Three-Dimensional Diffractive Acoustic Tomography

This file contains all reviewer reports in order by version, followed by all author rebuttals in order by version.

Version 0:

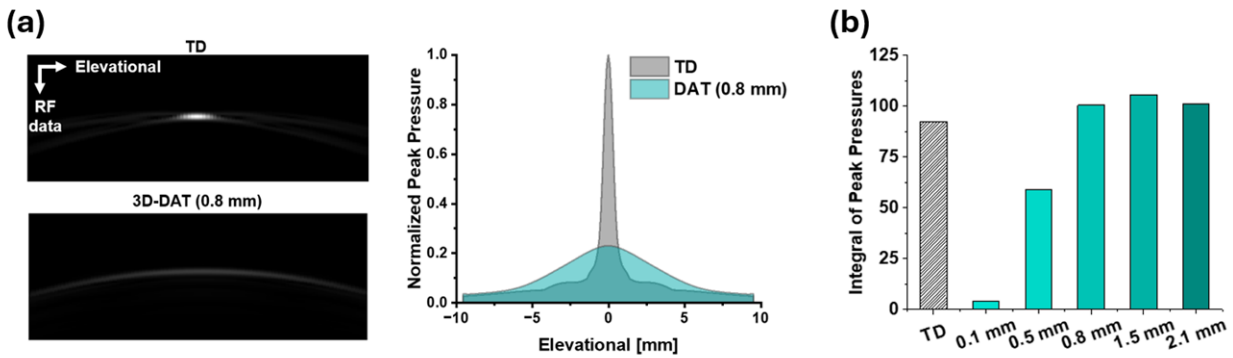
1. In Supple Fig. 1, please explain why the signal from P1 decreases when there is a slit, while P2 signal increases. Is this a trade-off noticed for the sources on the elevational axis? If so, why does it happen. This trade-off needs to be mentioned in the main manuscript. Also, please explain the underlying physics behind it.

Response: The decrease in the on-axis P1 signal is due to the slit, which partially blocks the passage of the acoustic energy. However, due to the increased detection angle with the slit's diffraction effect, the off-axis P2 signal becomes stronger. This improved detection angle is the fundamental advantage of 3D-DAT. The improvement in resolution due to single-slit diffraction is explained in the newly-added **Supplementary Note 1** and **Supplementary Figure 2**. Additionally, **Supplementary Figure 8** includes a new simulation quantifying the decrease in the in-focus acoustic pressure and the increase in the detection angle. The main results of this new simulation are also included in **Figure 2**, and presented in **Figure R1** below.

Figure R3. Segmentation of vessels. A control pregnant mouse image is shown on the left, the segmented vessels overlaid on the image in the middle, and the final binary segmentation of the vessels on the right.

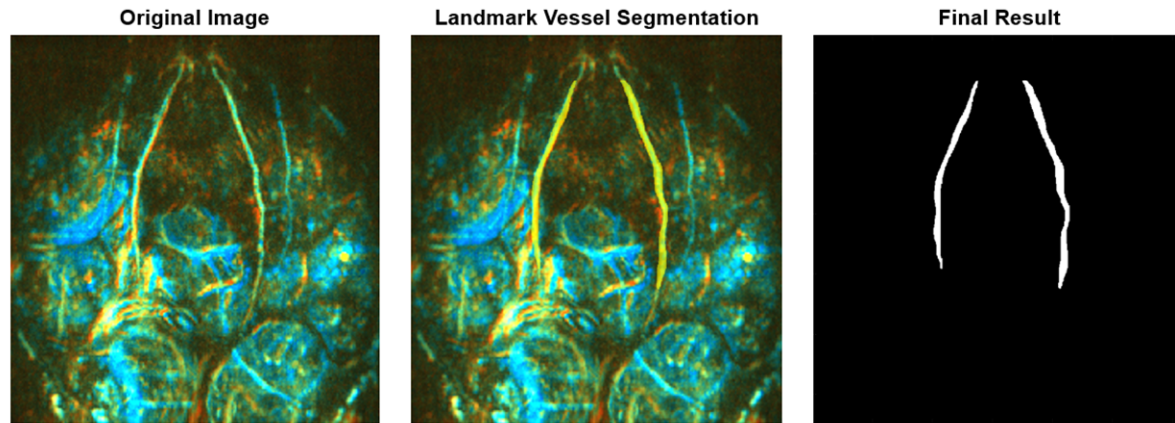
30. 622: How were the vessels segmented?

Response: Vessel segmentations were done manually, using the two main landmark skin vessels in the mice (see image below). For the pregnancy study, embryos were segmented manually, and the segmentations were validated from the corresponding high-frequency US data. We have updated the manuscript to include this information in the referenced section on page 25.
